AMENDMENT 2 AMENDEMENT 2

Household and similar electrical appliances – Safety – Part 1: General requirements

This amendment has been prepared by IEC technical committee 61: Safety of household and similar electrical appliances.

Figure 13 – Small parts cylinder

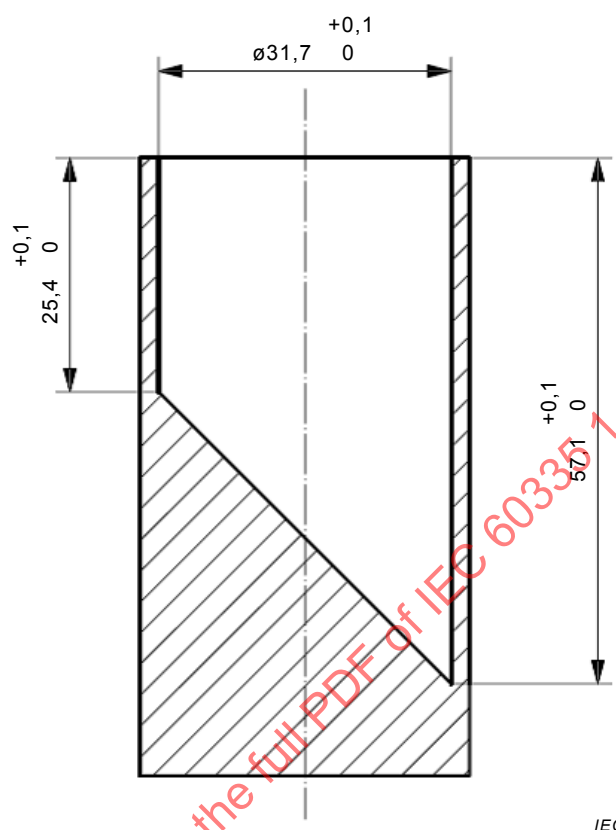
If the part is removed and can be contained within the small parts cylinder in Figure 13, its loosening is considered to result in a choking hazard.

Add the following new figure.

Figure 13 – Cylindre pour petites parties

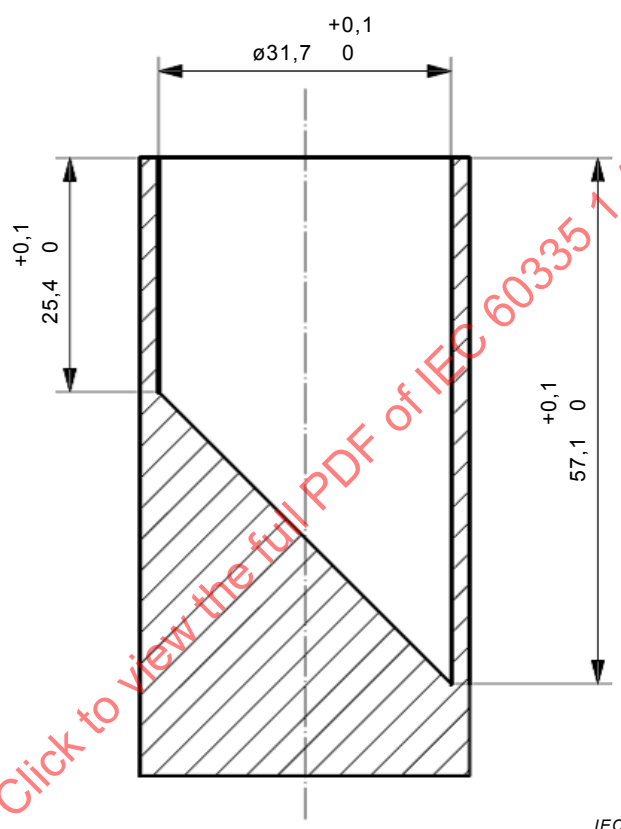
Si la partie est retirée et peut être contenue à l'intérieur du cylindre pour petites parties de la Figure 13, son desserrage est considéré comme pouvant entraîner un danger d'étouffement.

Ajouter la nouvelle figure suivante.
